DETAILED ACTION

This is the first Office Action for the serial number 10/814,478, RETAINING CLIP WITH OFFSET LATCHING FINGERS, filed on 3/31/04.

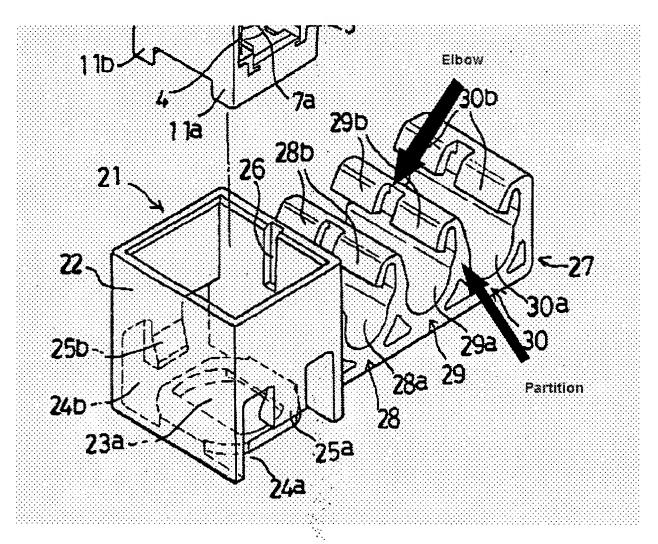
Tomoyoshi teaches the partitions and latching fingers but fails to teach the partitions are elbowed between the latching fingers. Miura teaches the partition (see drawing below) is elbowed between the offset latching fingers (29b). It would have been obvious for one of ordinary skill in the art at the time the invention was made to have added elbow to Tomoyoshi's partitions and latching fingers as taught by Miura to provide support for the both fingers to remain in an upright configuration when an object is inserted in the receiver which will cause the fingers to move in different direction from each other.

Tomoyoshi teaches the partitions and latching fingers but fails to teach the partitions are elbowed between the latching fingers. Miura teaches the partition (see drawing above) is elbowed between the offset latching fingers (29b). It would have been obvious for one of ordinary skill in the art at the time the invention was made to have added elbow to Tomoyoshi's partitions and latching fingers as taught by Miura to provide support for the both fingers to remain in an upright configuration when an object is inserted in the receiver which will cause the fingers to move in different direction from each other.
